FINAL
Mitigated Negative Declaration
and Supporting Initial Study
for Southern California Edison Company's

Banducci Substation Project

(A.12-11-011)

**California Public
Utilities Commission**

Figure 5.9-1
Hydrology and Floodplain Boundaries

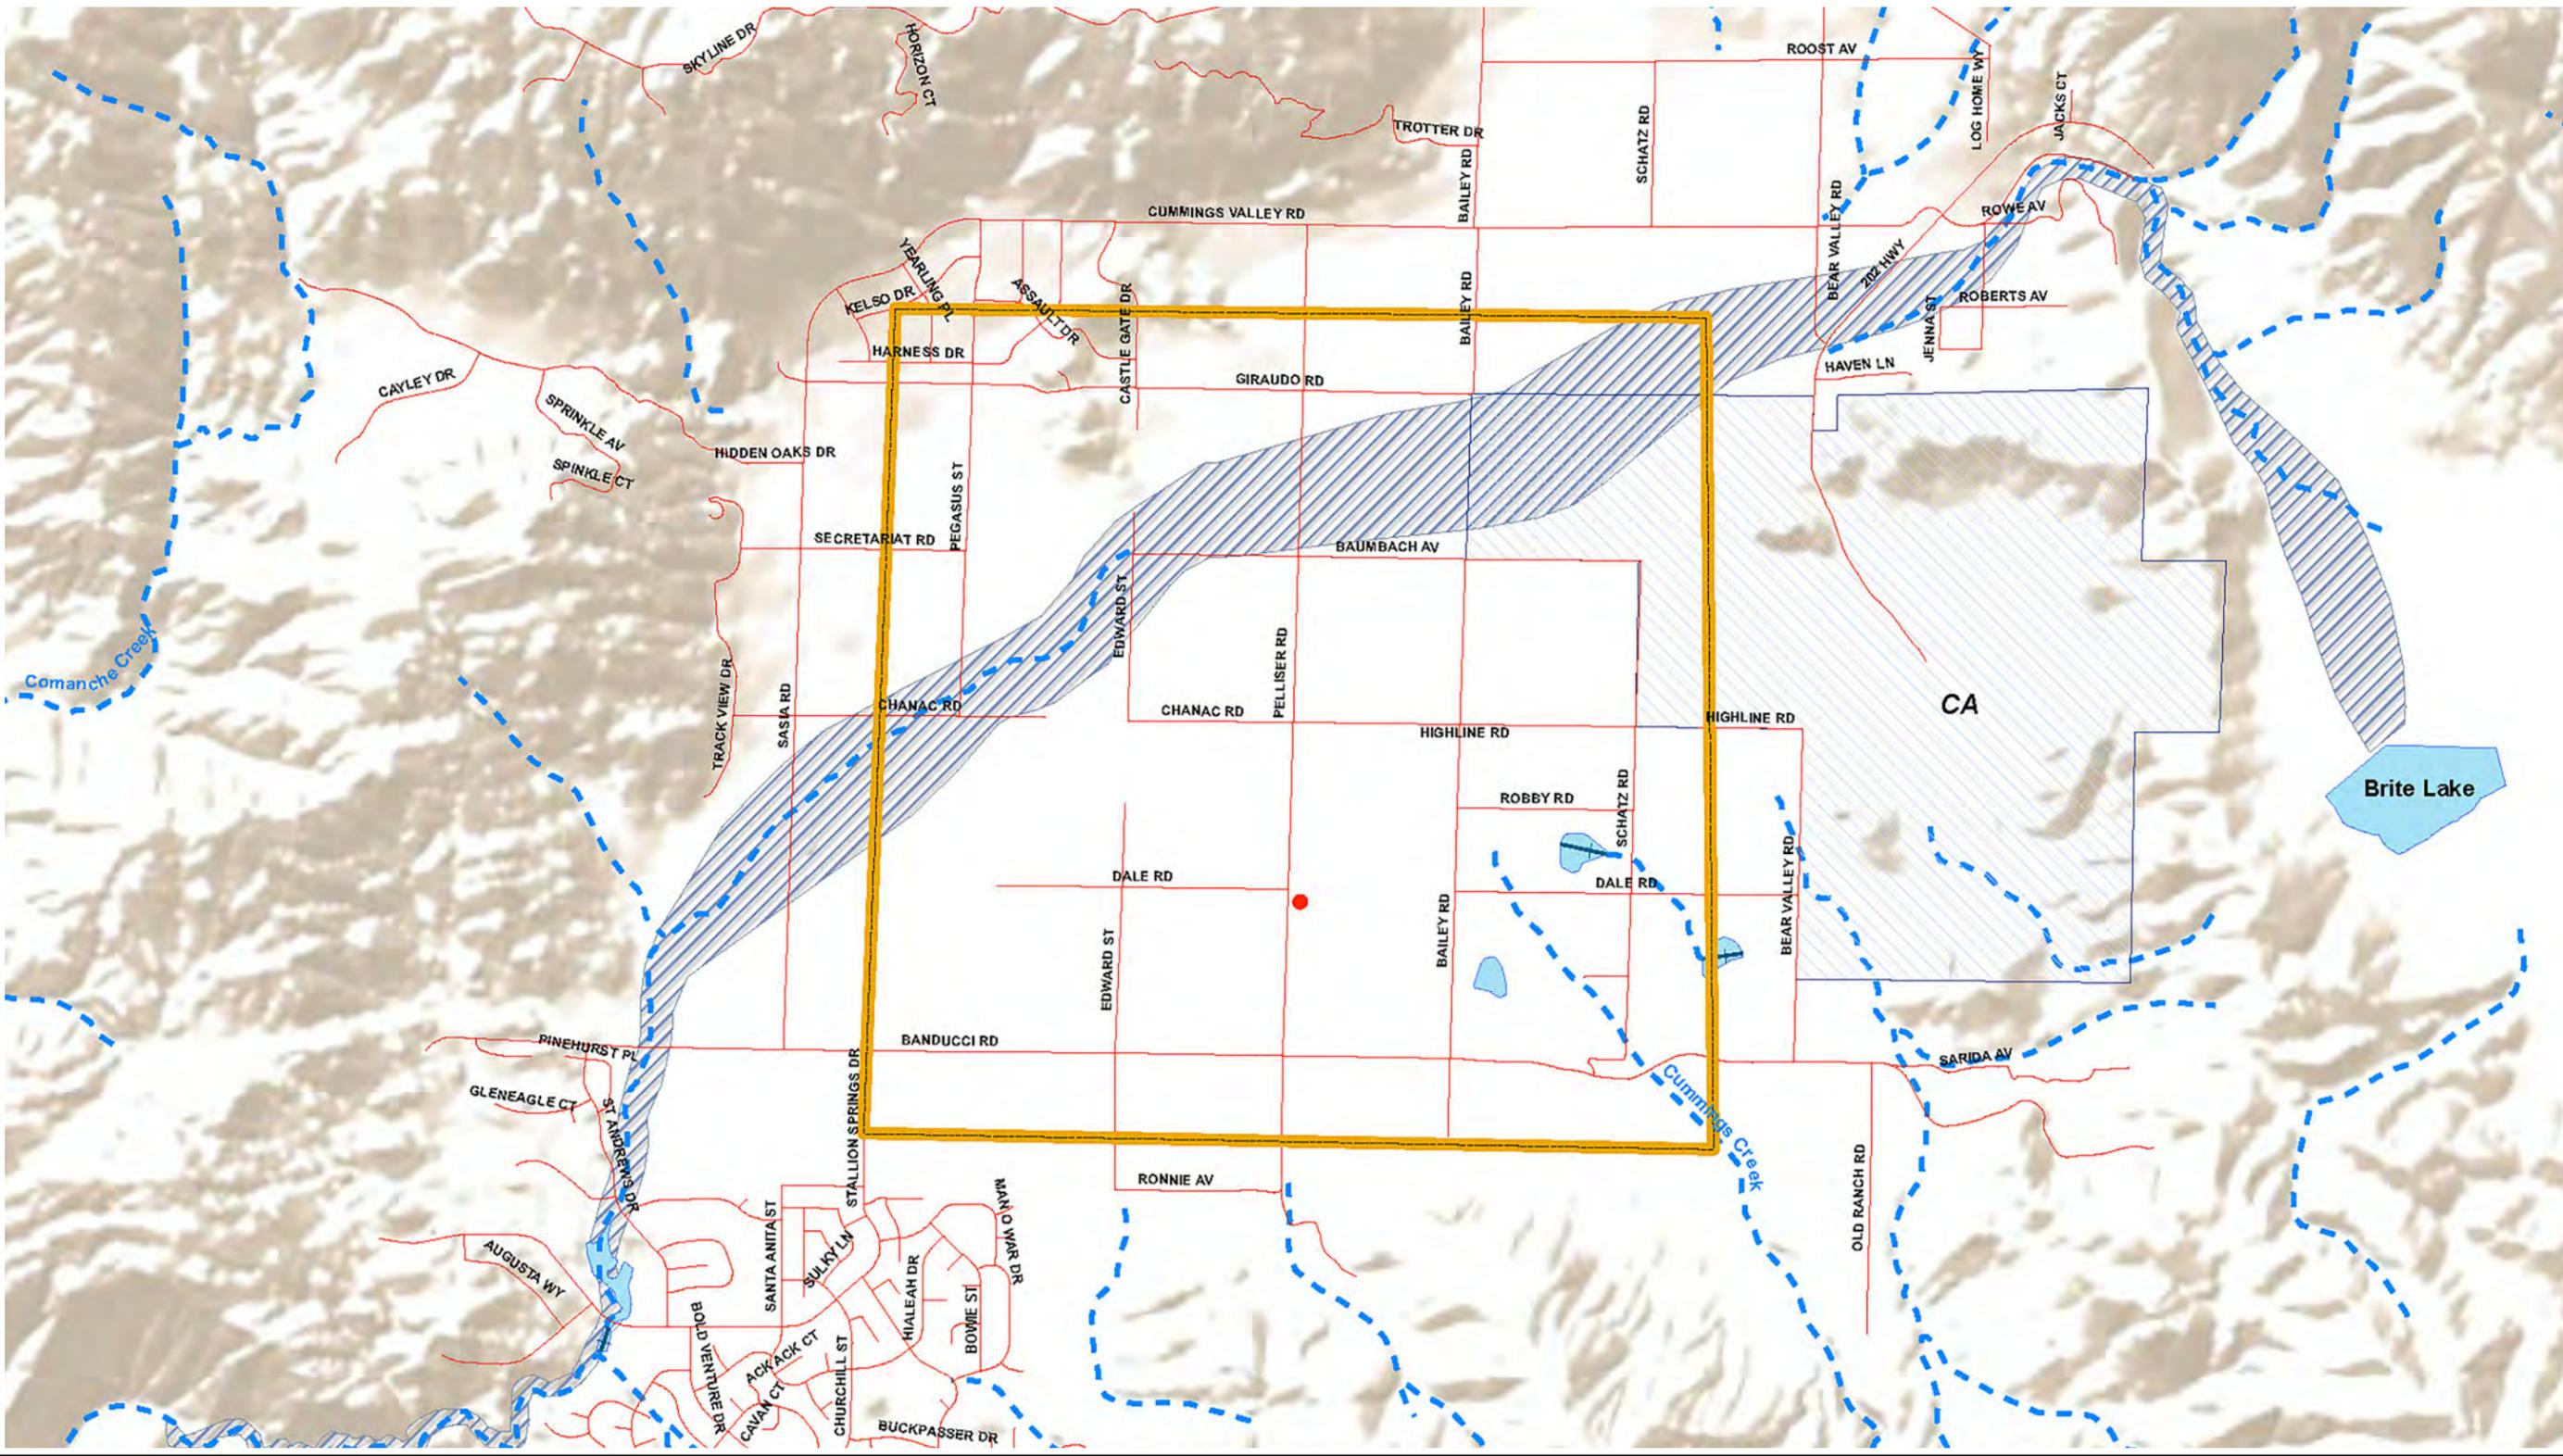
I note that Figures 5-9-1 and 5-9-2 (mentioned on pages 5-181 and 5-182, respectively) were missing from both the hardcopy MND and the enclosed CD. These figures were supposed to show surface and groundwater features. Also there were no tables within the MND summarizing the affected aquatic resources within the Project area. I strongly recommend that a table be included in the Final MND that lists the following for each affected surface water of the state: water body name/nearest downstream named water body, Basin Name and Hydrologic Code, assigned beneficial uses of the water body, whether perennial or ephemeral, and water body type (wetland, stream, lake, pond etc.). Please also note if any of these receiving waters are CWA Section 303(d) listed for pollutants, and if so, for which pollutants. It would also be very useful to know what the potential impact at each site would be and which APMs would be proposed applied to each affected site.

Chapter	Page	IS/MND Language	SCE Recommendations
5.9.1	5-181	Please see Figure 5.9-1.	It appears that Figure 5.9.1 is missing from the document.
5.9.1	5-182	...please see Figure 5.9-2	It appears that Figure 5.9-2 is missing from the document.

B-1 The commenter correctly noted that Figures 5.9-1 and 5.9-2, which represent water resources conditions in the Proposed Project area, are missing from Section 5.9.1 (Setting) in the Draft IS/MND. Figure 5.9-1 (Hydrology and Floodplain Boundaries), which was taken from SCE’s Proponent’s Environmental Assessment, has been added to the Final IS/MND to show surface water resources. Figure 5.9-2 (Groundwater Resources), also added in the Final IS/MND, shows the boundaries of groundwater basins underlying the Proposed Project area.

- D-31 The commenter correctly noted that Figures 5.9-1 and 5.9-2, which represent water resources conditions in the Proposed Project area, are missing from Section 5.9.1 (Setting) in the Draft IS/MND. Figure 5.9-1 (Hydrology and Floodplain Boundaries), which was taken from SCE's Proponent's Environmental Assessment, has been added to the Final IS/MND to show surface water resources. Figure 5.9-2 (Groundwater Resources), also added in the Final IS/MND, shows the boundaries of groundwater basins underlying the Proposed Project area. See also Response to Comment B-1.
